## MEMORANDUM

## FOUNDATION INVESTIGATION REPORT

Proposed Crossing at Bar Creek and  
Hwy. #638, Township of MacDonald  
S.W. 1/4 Sect. 24 and N.W. Sect. 25  
District of Algoma  
District No. 18 (Sault Ste. Marie)  
W.J. 68-F-77 -- W.P. 263-66-02

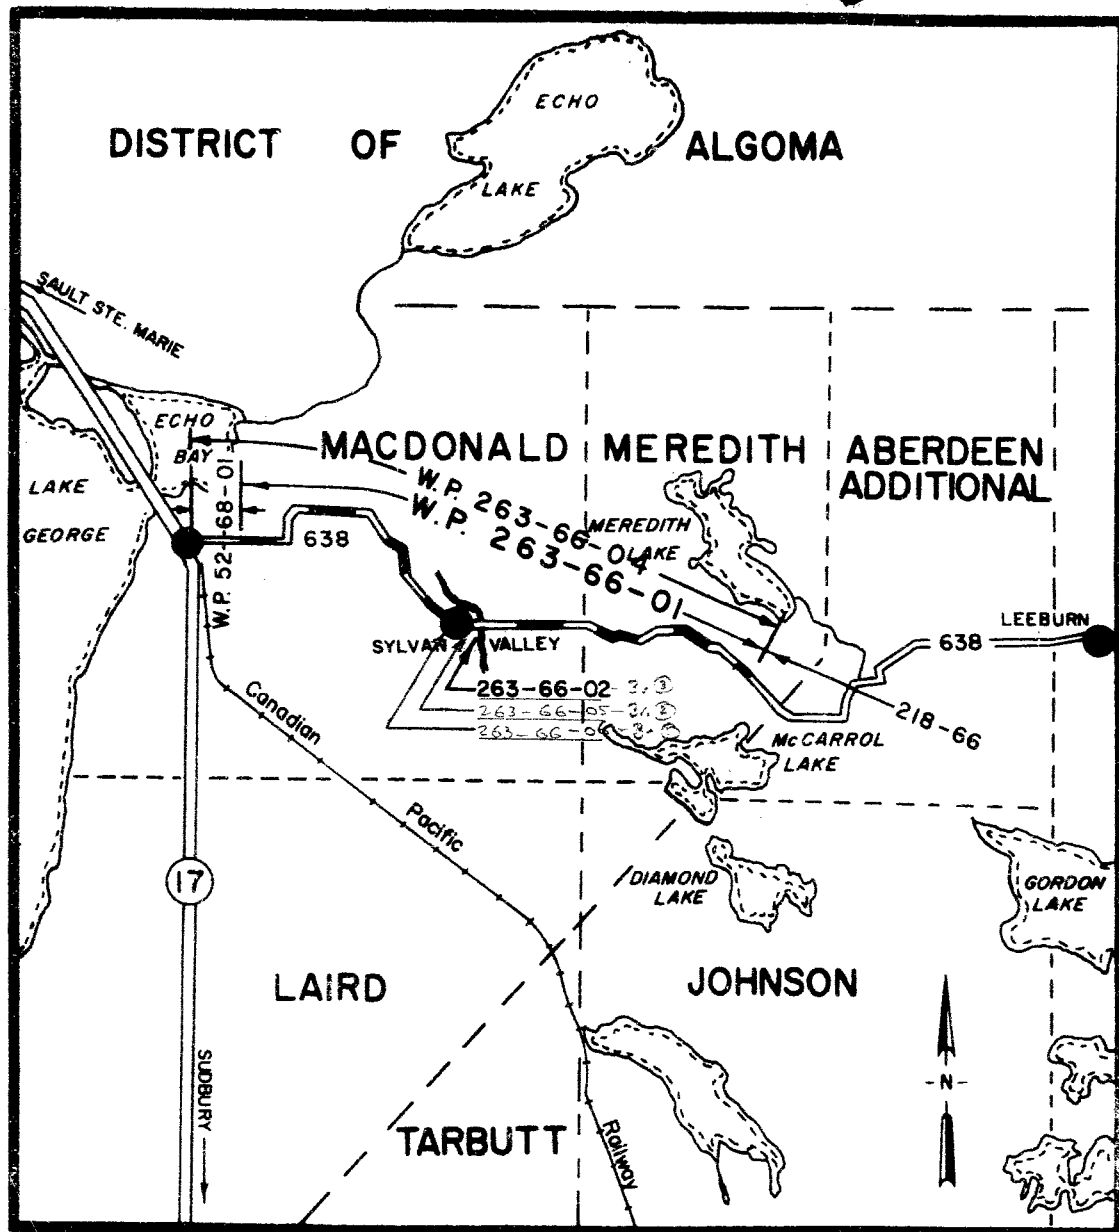
Note for pile driving should read: "No. 14 creosoted timber piles  
driven to tip el. -- "

(Bridge #1 Tip El. 607.5)

(Bridge #2 Tip El. 608.0)

(Bridge #3 Tip El. 593.0)

Mention of design load might imply use of Hiley Formula which is  
not valid at this site.
